DEPARTMENT OF WATER RESOURCES

September 7, 2010

The Department of Water Resources has received your statutory claim application 11-7586 and filing fee. However, we are unable to complete the processing of this claim because some of the information on the application appears to be incorrect. Purpose of this letter is to notify you of the problem and to assist you with making the correction. The problem is described below.

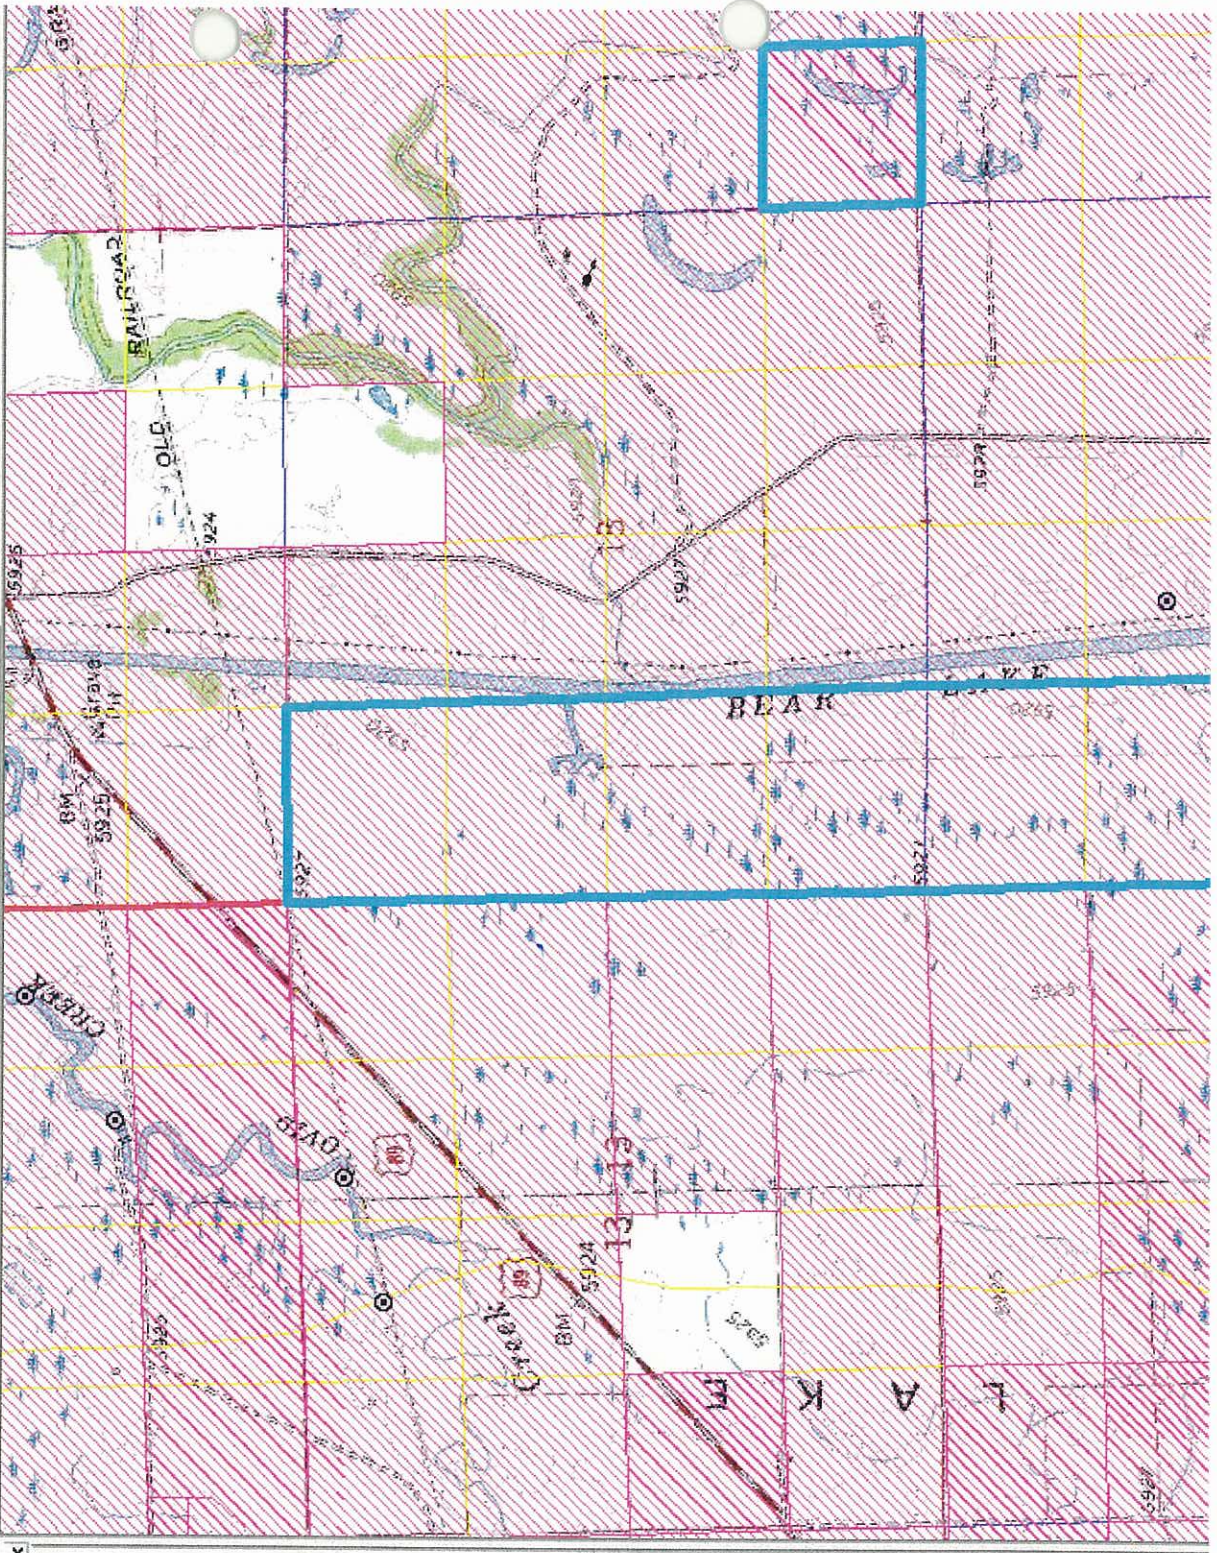
The two parts of claim application 11-7586 which identify the place-of-use are in conflict with each other. The application map shows the place-of-use in sections 19, 18 and in section 7. However, the grid description of the place-of-use lists acreage in use in sections 19, 18 and in section 17. Section 17 is some distance from section 7 so this may be a simple typographical error, however the map and the grid must match before processing can continue. The place-of-use of your claim should be where the historical water use occurred. The historical place-of-use may not be the same as your current place-of-use.

1)If the grid is correct, then you need to correct the map because the map you supplied doesn't show any acreage identified in section 17. For your convenience, I have enclosed copies of two different maps. One map was submitted as an attachment with your statutory claim application. You should be able to see that section 7, not section 17 is directly north of section 18.

The other map was generated by the database and shows two places-of-use: a rectangle outlining several adjacent quarter-quarters in sections 18 and 19 and, a single square to the east, separated from the others. That single square represents the quarter-quarter in section 17 that you have described in question 6, the PLS grid of your claim application.

2)If the aerial photo-map showing a small triangular piece in section 7 is the correct map, then the grid description on your application needs to be corrected. The

You have two options. Either 1)correct the map or 2)correct the Public Land Survey (PLS) grid section on your claim application.

To assist you with correcting the grid, I have enclosed a copy of the statutory claim as you have submitted it, and a blank page 2 of that form which you can use to make the correction. I have also enclosed a revised place-of-use grid with section 7 substituted for section 17. I created the revised place-of-use grid to match the aerial photo-map you had attached to your application. If your aerial photo-map is correct, then the revised place-of-use grid is correct. And you will need to copy it into question 6 on the blank page 2 that I provided. You will also need to re-enter all the information for question 7 and 8 into that corrected page 2, and sign and notarize your signature.

Please return the proper pair of documents to me at the address listed in the header of this letter. The matched pairs would be your old aerial photo-map and the revised grid in a corrected claim form, page 2 or your old application form and the new map created by the database. I will update the claim file paperwork and the database records to agree with whichever pair of documents you return to me.
